**APPLICATION FOR PERMISSION
UNDER SECTION 16 OF
THE TOWN PLANNING ORDINANCE
(CAP. 131)**

Application No. 申請編號	(For Official Use Only) (請勿填寫此欄)		
Location/address 位置/地址	Lots 788 (Part), 790 (Part), 793, 794 and 801RP in D.D. 381 and Adjoining Government Land, Tuen Mun, New Territories		
Site area 地盤面積	<div style="display: flex; justify-content: space-between;"> 4,432 sq. m 平方米 <input checked="" type="checkbox"/> About 約 </div> <div style="display: flex; justify-content: space-between;"> (includes Government land of 包括政府土地 677 sq. m 平方米 <input checked="" type="checkbox"/> About 約) </div>		
Plan 圖則	Draft Tuen Mun Outline Zoning Plan No. S/TM/38		
Zoning 地帶	"Open Space" ("O") and "Government, Institution or Community" ("G/IC")		
Applied use/ development 申請用途/發展	"Proposed Temporary Place of Recreation, Sports or Culture (Barbecue Area and ancillary Electric Kiddie Ride) and Temporary Holiday Camp (Private Tent Camping Ground)" for a Period of 6 Years

Comments	Responses
a.	Plan 3a is found missing. Also, please provide the photos of ancillary kiddie ride;	Plan 3a is attached. The applicant will not provide any kiddie ride. The location is replaced by play activity area.

1:750 (A4)	LayoutPlan Lot No. 788(part), 790(part), 793, 794 & 801 RP in D. D. 381 and Adjoining Government Land Tuen Mun, New Territories	Goldrich Planners & Surveyors Ltd.
April 2024		Plan 3 (P 22015)

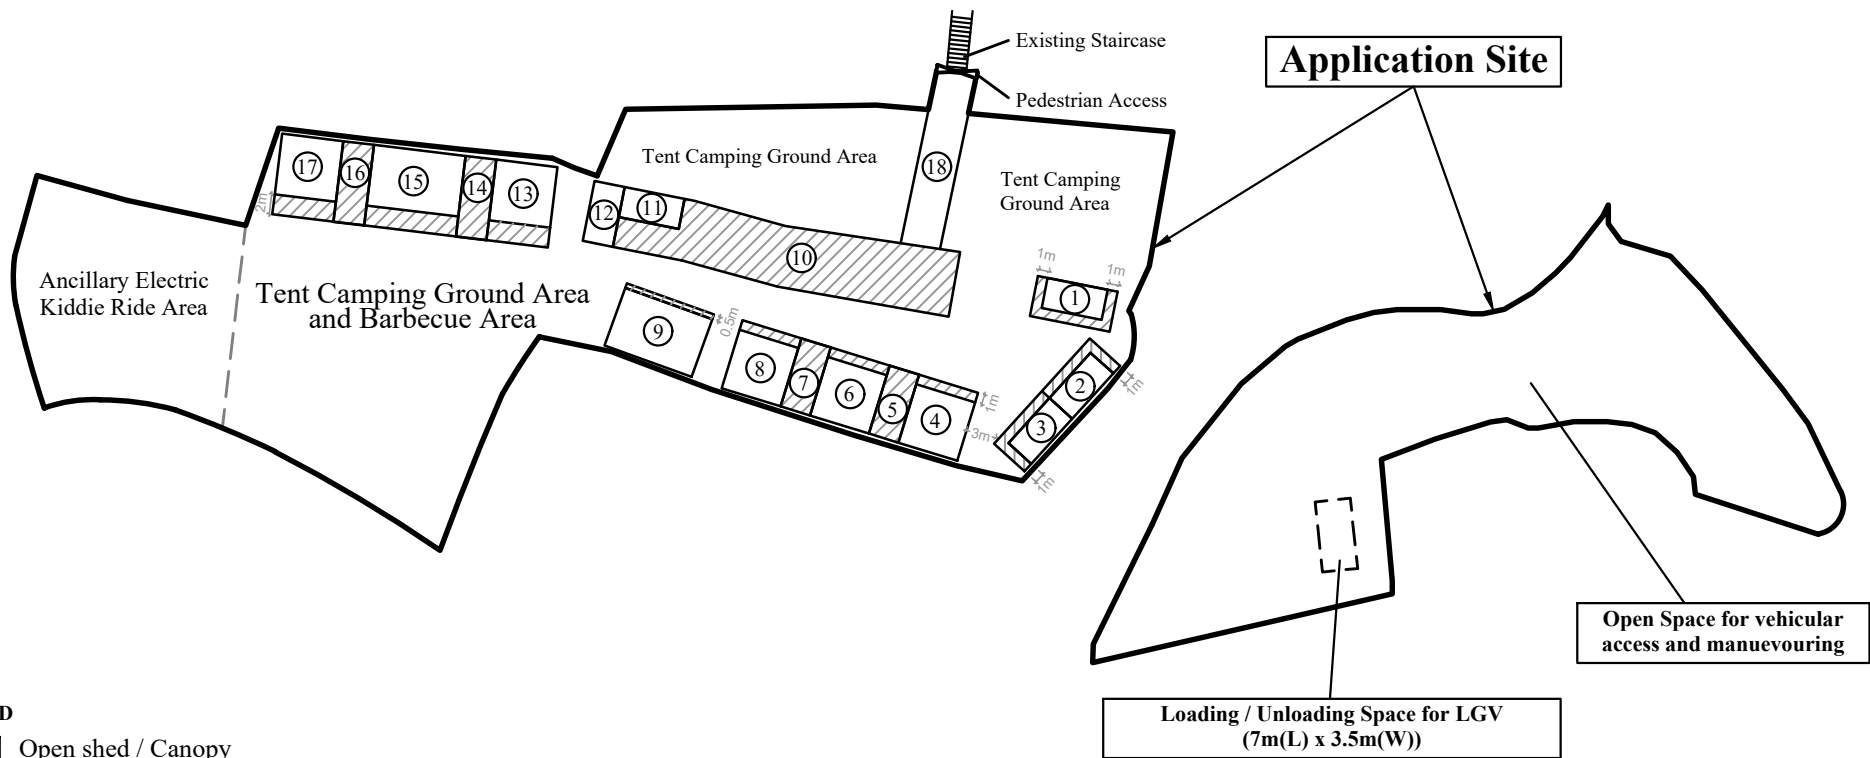
Comments	Responses
(a)	Plan 3 – please elaborate what types of activities would be accommodated within the “Function Room”;	Video games and boardgames would be accommodated within the “Function Room”.

**Plan 4
(P 22015)**

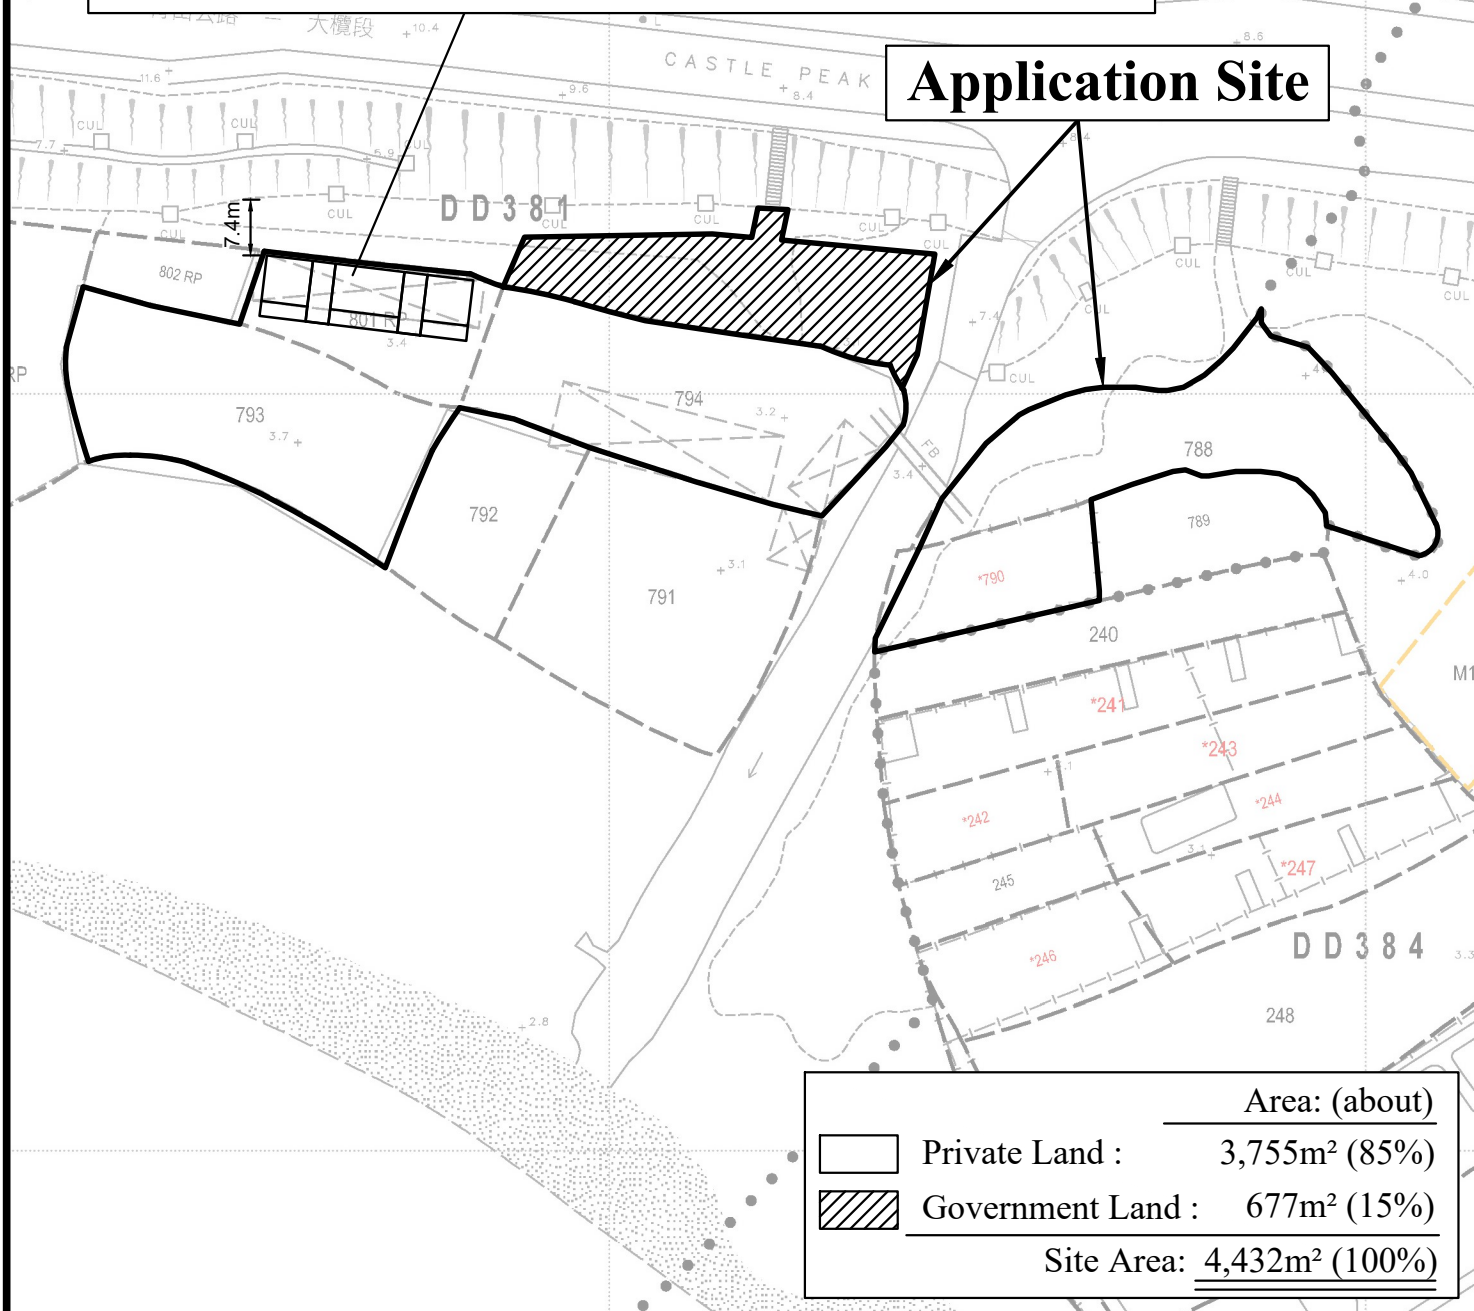
Comments	Responses
2.	The subject planning application may affect or be affected by Feature No. 6SW-D/F278 (maximum height about 10m) and meets the criteria for submission of a Geotechnical Planning Review Report (GPRR) to support the application. The application is required to submit a GPRR in support of the captioned planning application. The essential contents of a GPRR are given in the attached GEO Advice Note (Annex A).	The proposed use is “Proposed Temporary Place of Recreation, Sports or Culture (Barbecue Area) and Temporary Holiday Camp (Private Tent Camping Ground). Three containers are placed on the private lots and some tents are proposed on the adjacent Government Land. The nearest distance of the structures is about 7.4m from the foot of Feature No. 6SW-D/F278. No construction works will be carried out. The proposed activity will not affect the stability of the Feature No. 6SW-D/F278 and the retaining wall. Therefore, no Geotechnical Planning Review Report is required. Please refer to the plan showing the distance between the foot of the man-made slope and the nearest structure (Plan 4a) for details.

Plan 3b
(P 22015)

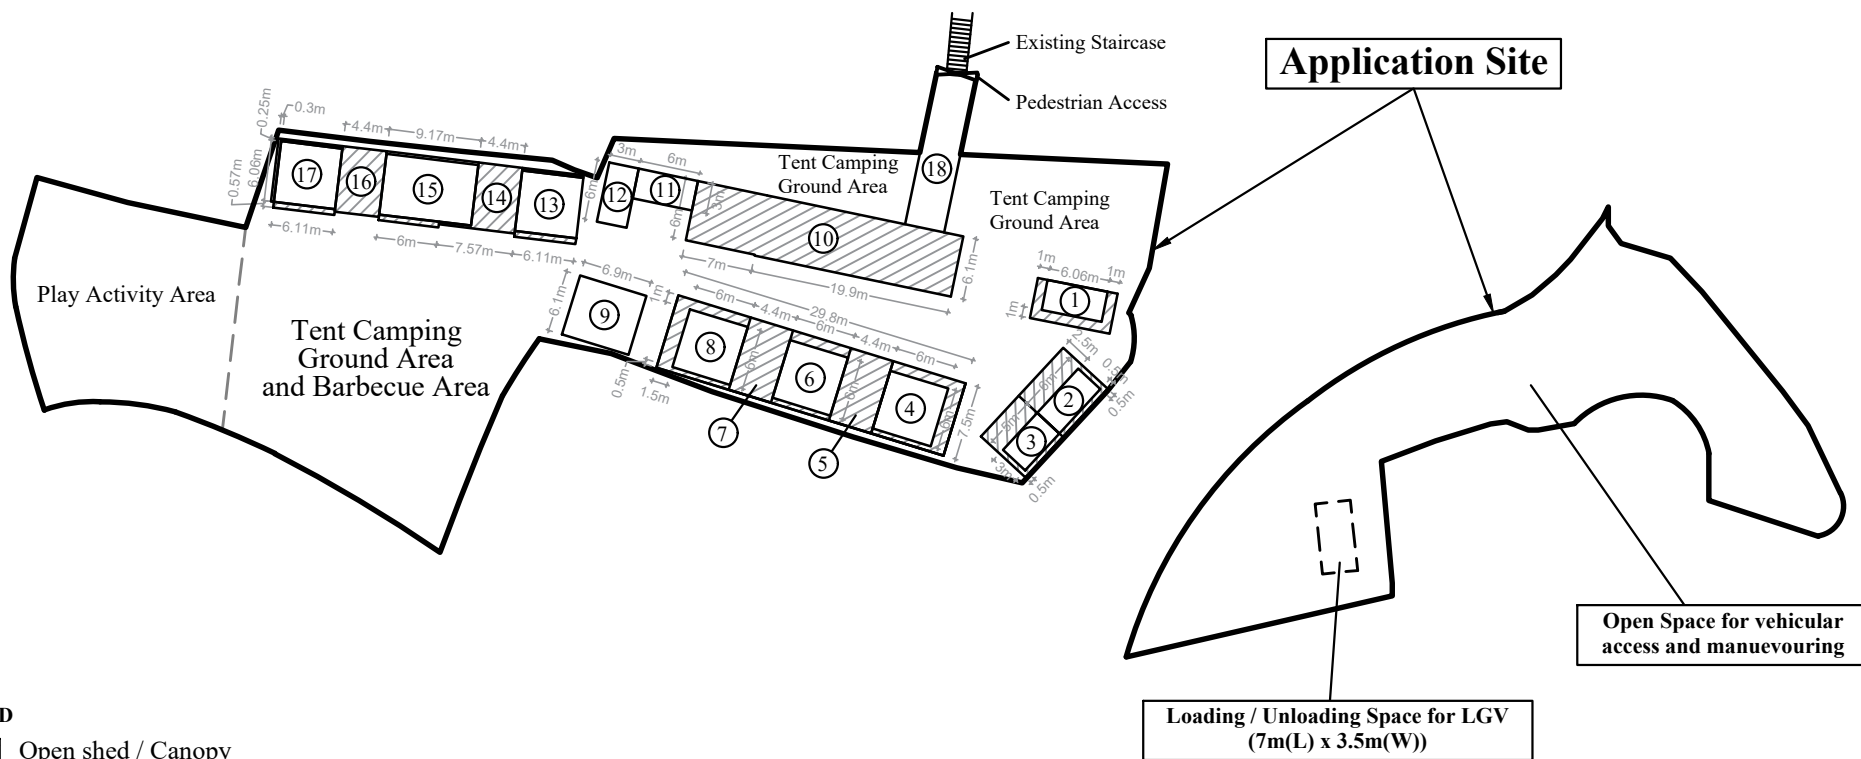
Comments	Responses																								
2.	<p>A site inspection conducted on 31.7.2024 revealed that all unauthorized tents and storeroom not covered by the subject application and miscellaneous items on Government land identified during the site inspections on 19.4.2024 and 27.6.2024 respectively had been removed. As regards an unauthorized porch not covered by the subject planning application and the discrepancy between the built-over area of the unauthorized structures covered by the subject application as shown on the layout plan provided by the applicant (i.e. structures nos. 2 to 9 as shown in Plan 3b (P 22015) dated July 2024) and our on-site measurement during previous site inspections vide para. 2 in our memo under ref. (84) in DLOTM 14/MAT/23 dated 6.5.2024 [note to applicant: please refer to para.2 of DLO/TM’s comments vide PlanD’s email dated 8.5.2024], the applicant is required to clarify the discrepancy and rectify the unauthorized porch not covered by the subject planning application (see attached plan).</p> <p><i>[See attachment "Plan A_TM_592 FI dd 26.7.2024.pdf"]</i></p>	<p>The layout plan is updated. Structure nos. 2 to 9 are updated to be the same as the current situation. Portion of the porch (northern side) of structures 4 to 8 has been removed The updates are as follows:</p>

3.	However, our re-site inspection conducted on 14.10.2024 revealed that some unauthorized tents and porches not covered by the subject application as shown on the plan attached on our memo dated 6.5.2024 were repeatedly erected within the Site and there were discrepancies between the B.O.A. of the unauthorized structures covered by the subject application as shown on the layout plan provided by the applicant (i.e. Structure nos. 4 to 10 & 13 to 17 as shown in Plan 3b (P 22015) dated August 2024) and our on-site measurement of 14.10.2024. Moreover, a footbridge was placed over a section of existing nullah/natural stream which fell within Government land sandwiched between the application site and Lot No. 788 in D.D.381 without our permission. Any occupation of Government land without Government's prior approval is an offence under Cap. 28. This office reserves the rights to take necessary land control action against the unlawful occupation of Government land without further notice.	<p>The applicant has rectified the situation after 14.10.2024. The structures are tally with the Layout Plan (Plan 3b).</p> <p>The footbridge has been removed.</p> <p>The B.O.A of the structures will be tally with the Layout Plan (Plan 3b).</p>

<p>Note: BOA (Built-over area)</p> <p>Please refer to updated layout plan (Plan 3b) for details.</p>	Structures no(s).	BOA in Plan 3a (Previous plan)	Measurement by applicant on 13.8.2024	BOA in Plan 3b (Updated plan and current situation)	2 and 3	58m ²	72m ²	72m ²					4, 5, 6, 7 and 8	173m ²	270.91m ²	223.5m ² (after removal of portion of porch)	9	60m ²	<u>42.09m²</u>	42.09m ²			<u>313.00m²</u>	
Structures no(s).	BOA in Plan 3a (Previous plan)	Measurement by applicant on 13.8.2024	BOA in Plan 3b (Updated plan and current situation)																							
2 and 3	58m ²	72m ²	72m ²																							
4, 5, 6, 7 and 8	173m ²	270.91m ²	223.5m ² (after removal of portion of porch)																							
9	60m ²	<u>42.09m²</u>	42.09m ²																							
		<u>313.00m²</u>																								
3.	<p>It is noted from the revised Form No. S16-1 attached to the FI that the proposed building height of each structure is revised to 6m from 4m while the proposed no. of storey remains at 1 storey, such proposed building height of 6m (about) for one- storey structure is considered excessive, please request the applicant to justify. You may also wish to note that from our recent on-site measurement, the building height of the existing structures covered by the subject planning application varies from 2.5m to 4.5m (approximate).</p>	<p>The building height of the structures is updated. Please refer to updated layout plan (Plan 3b) for details.</p>

**Plan 4b
(P 22015)**

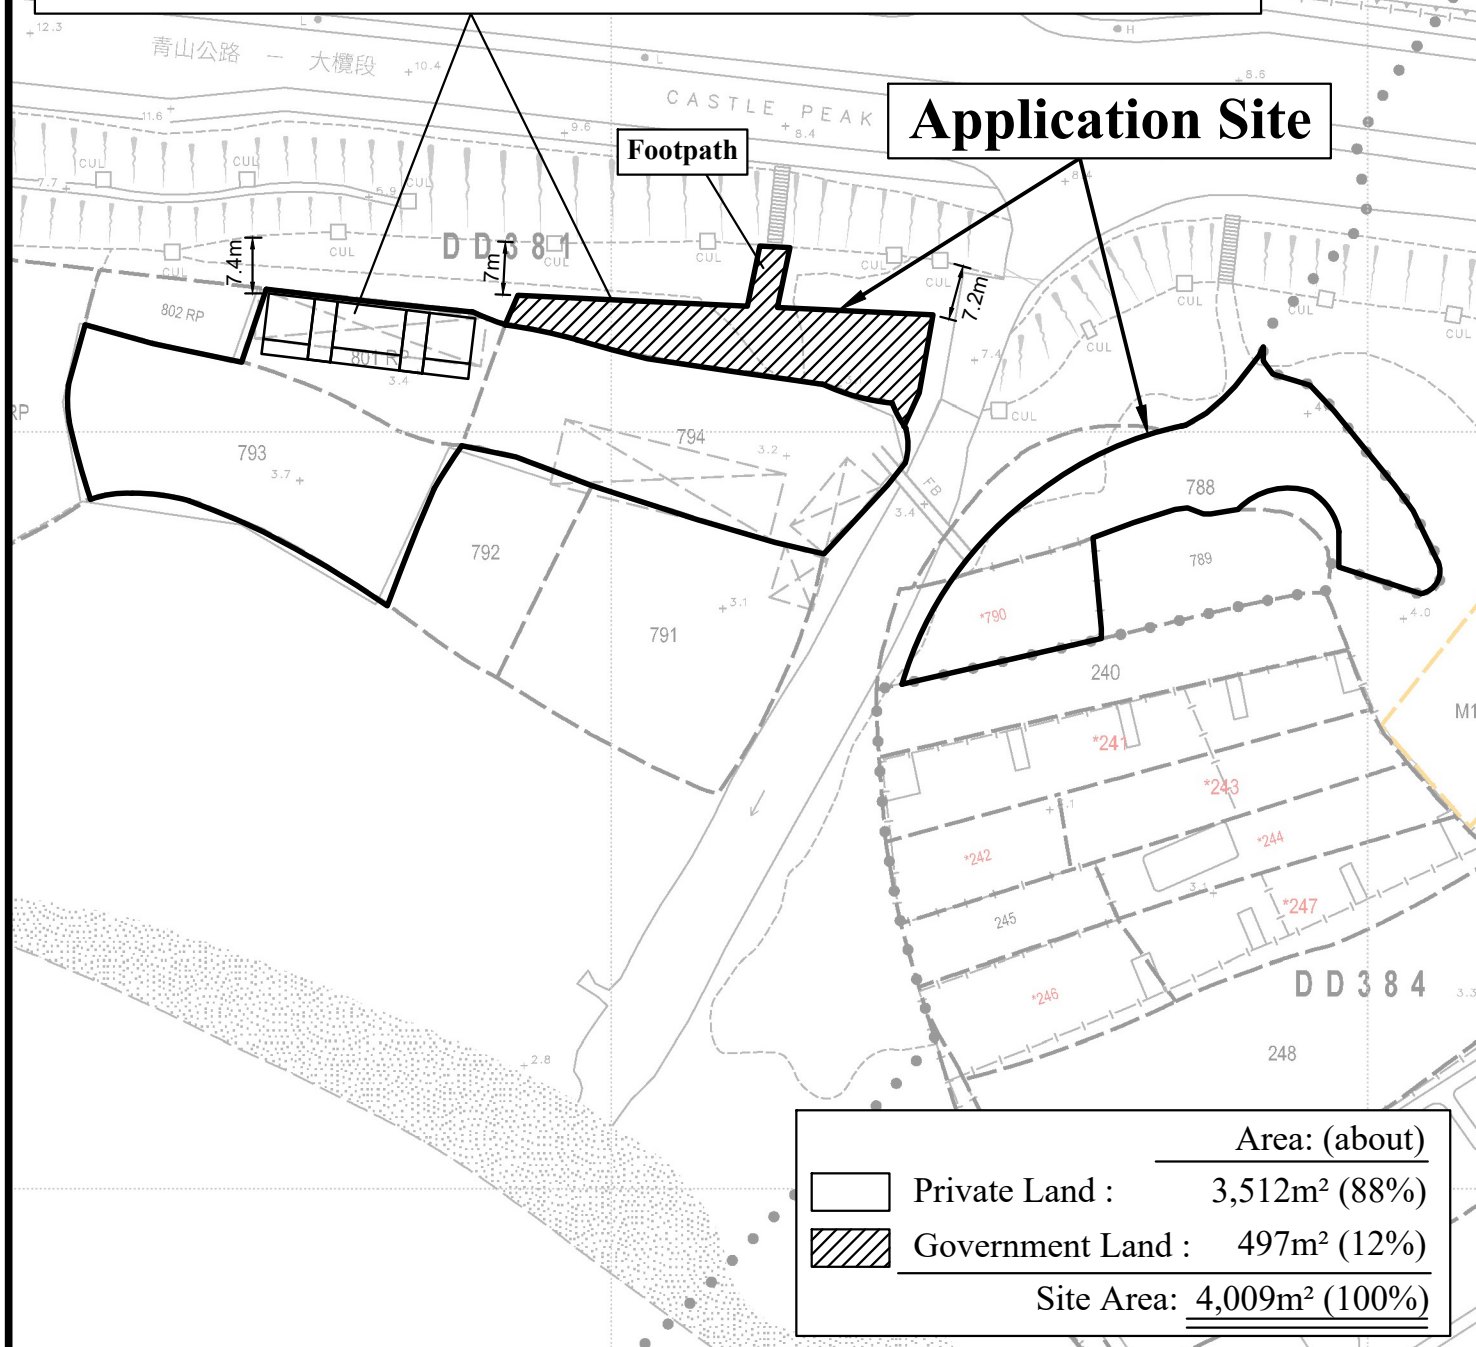
Comments		Responses
2.	R-to-C item 2 and Plan 4a in the FI - The applicant's responses are noted. It is noted that some tents are proposed on the adjacent Government Land at the toe of Feature no. 6SW-D/F278 (maximum height about 10m). As such, the subject application meets the criteria for submission of a Geotechnical Planning Review Report.		The layout is updated. The tent camping ground area is away from the slope at a distance of at least 7m. Please refer to the revised plans (Plans 3b and 4b). A GPRR may not be required.

The proposed Government Land is about 7m from the foot of the man-made slope.

The nearest distance of the structure is about 7.4m from the foot of the man-made slope.
